**Transport
for NSW**

Additional Information provided to Department of Planning and Environment to support the assessment of the CBD and South East Light Rail Project

This information was submitted in response to requests for further information requested by the Department of Planning and Environment since lodgement of the CSELR Submissions Report in March 2014.

CBD and South East Light Rail Project Independent Review of Noise/Vibration Assessment Response to Issues Raised

Figure 1: Peak Flood Depth and Level – Existing Conditions – 1% AEP Design Event

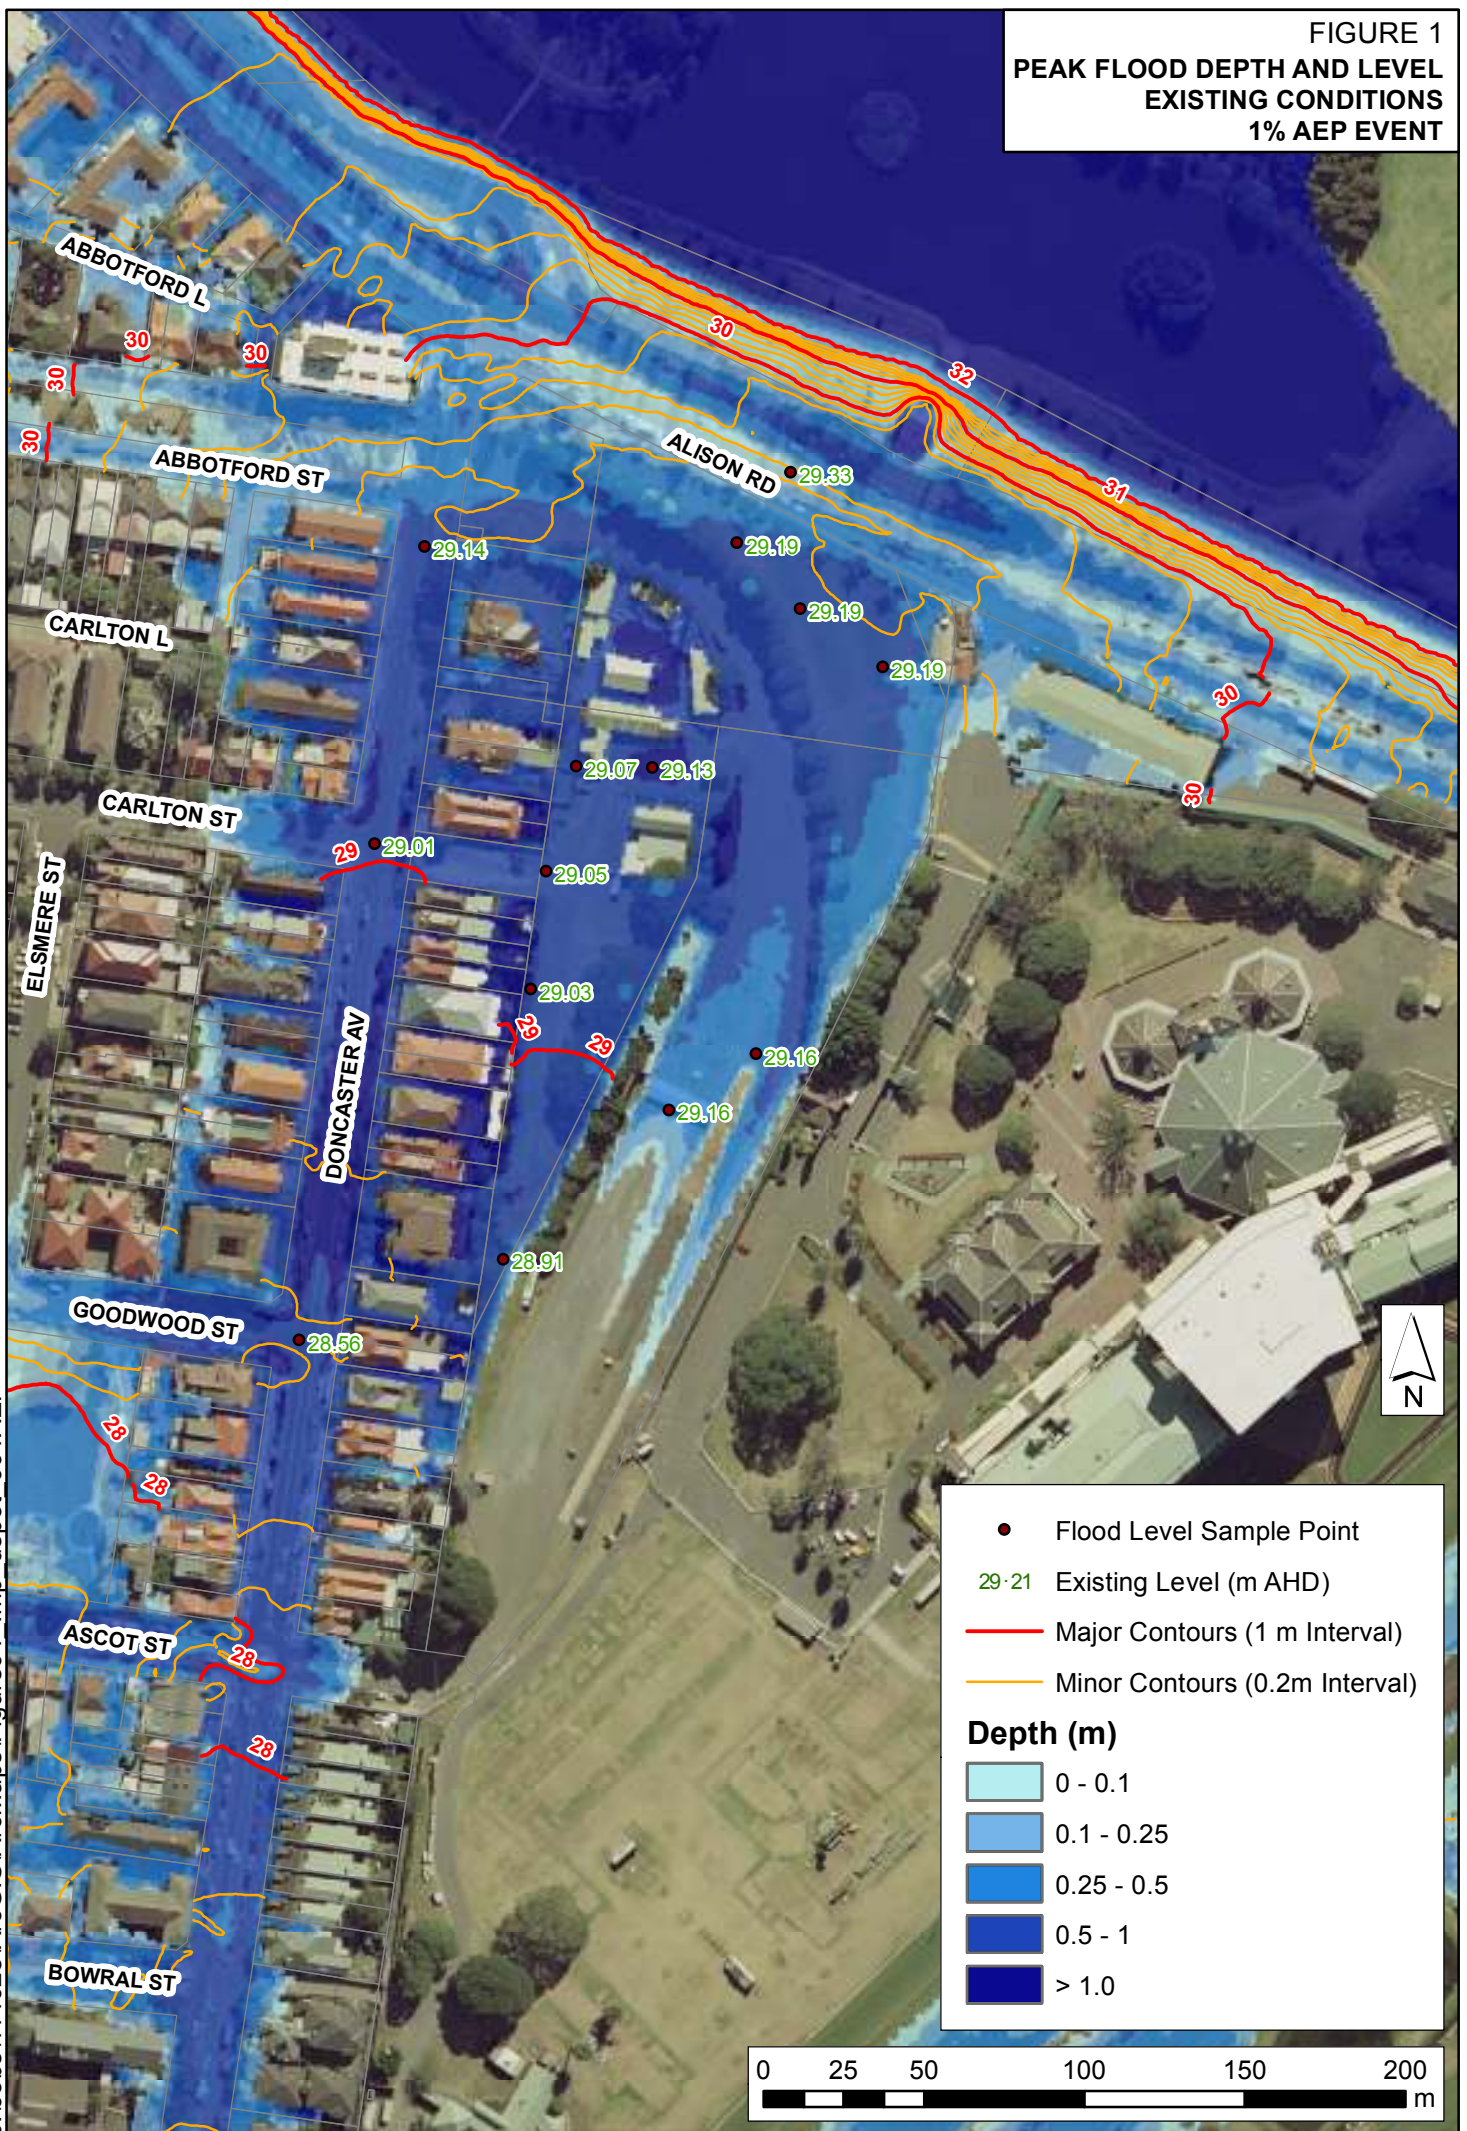
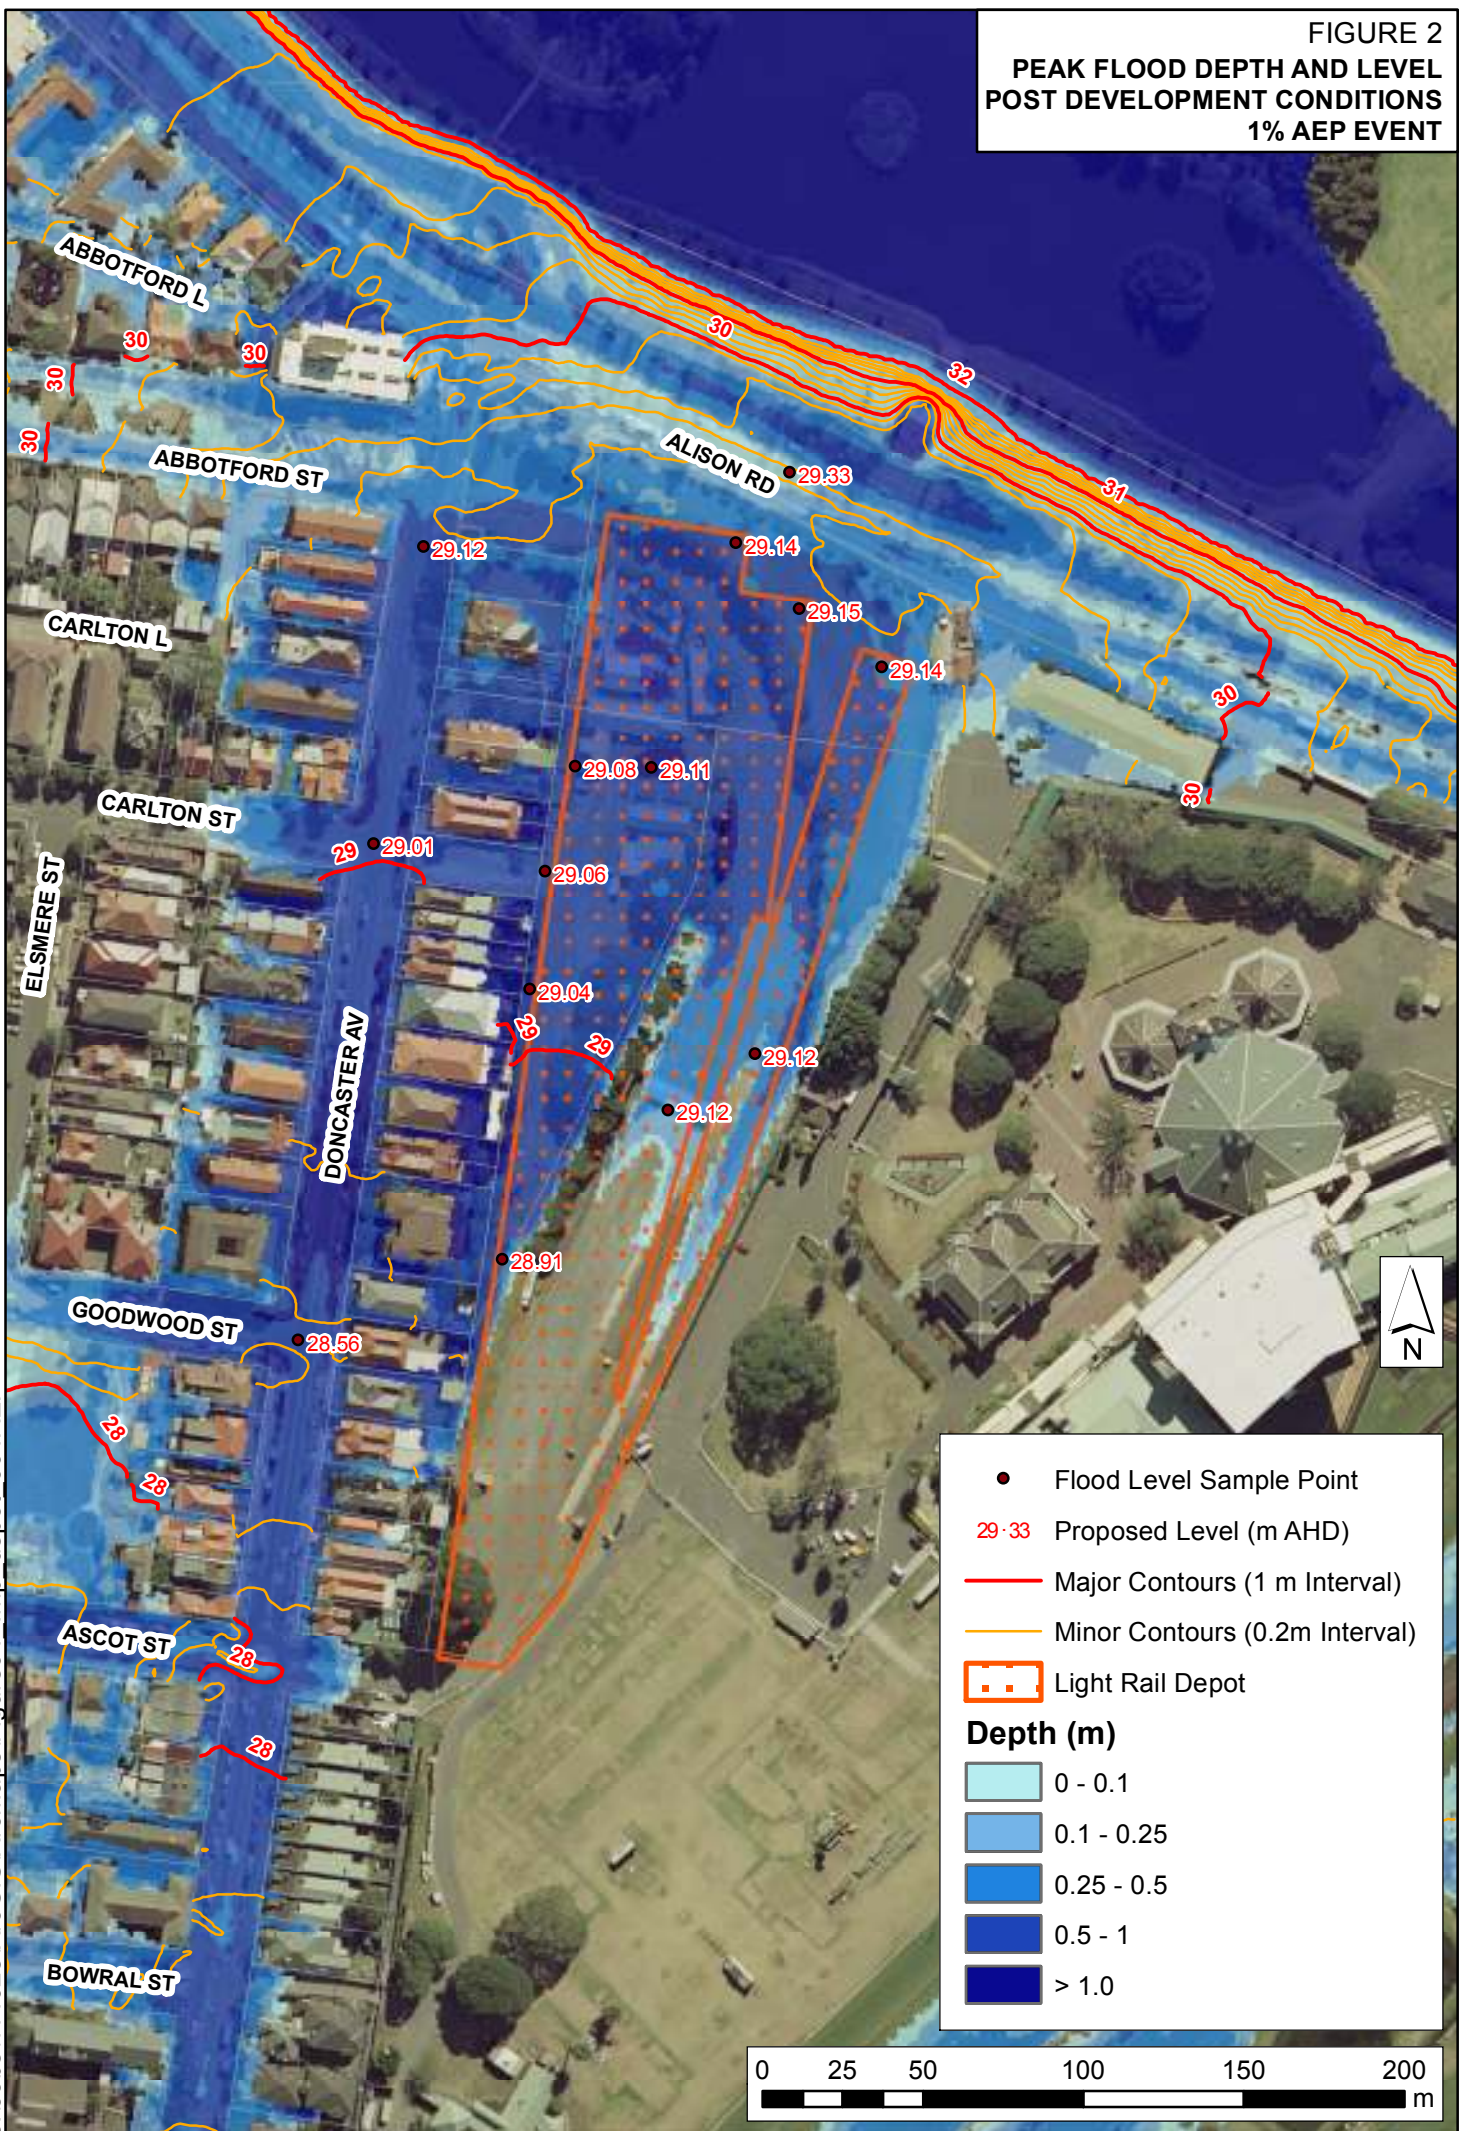
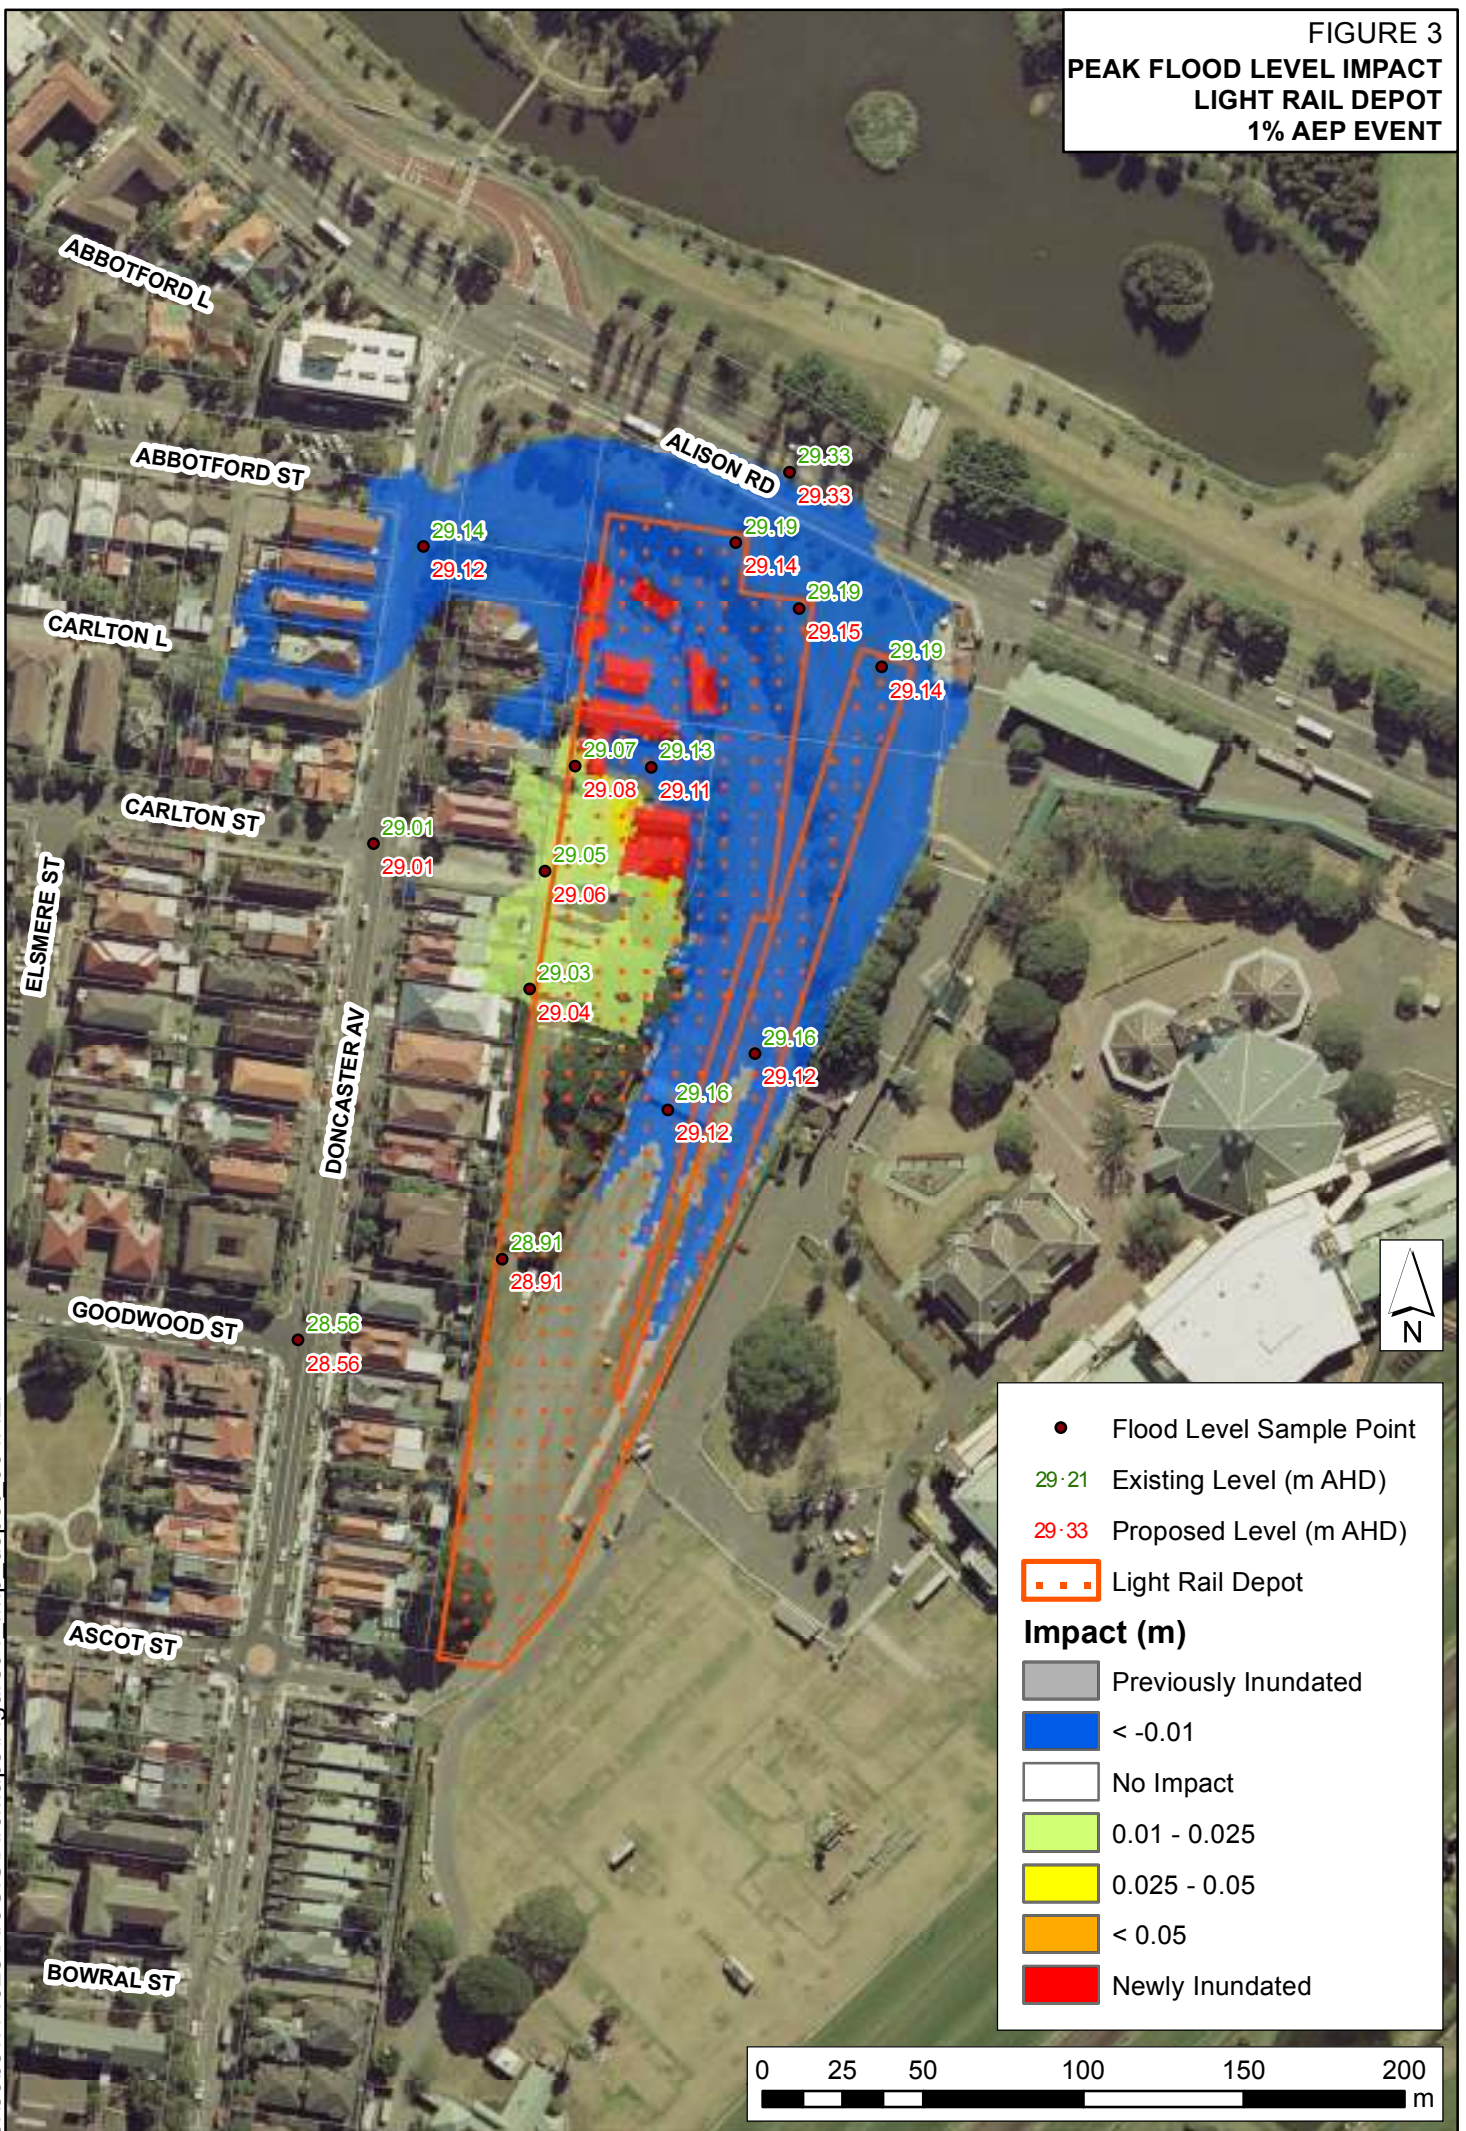
Referring to Figure 1 which shows existing flood behaviour, floodwaters enter the development site from Alison Road (north) before discharging through residential properties to Doncaster Avenue (south-west). The existing peak flood level for the site is 29.2 mAHD in the 1% AEP flood event (sampled along the northern edge of the development). The 1% AEP flood extent does not encroach to higher ground at the southern end (Figure 2) hence development on this part of the land does not have to be on piles.

In post-development conditions with the removal of existing buildings within the development site and introduction of the RC piles, the peak flood level upstream decreases to 29.16 mAHD in the 1% AEP flood event (refer Figure 2) which is expected as floodwaters are no longer impeded by existing buildings that serve as obstructions to flow. However, this results in a slight increase in peak flood levels downstream along the western boundary of the development site at the rear end of the residential properties on Doncaster Avenue. Figure 3 shows the 1% AEP flood impact of the development and it can be seen that a maximum localised impact up to 30 mm can be expected on the peak flood levels. Post-development flood velocities remains relatively unchanged from existing conditions and are generally <1 m/s.
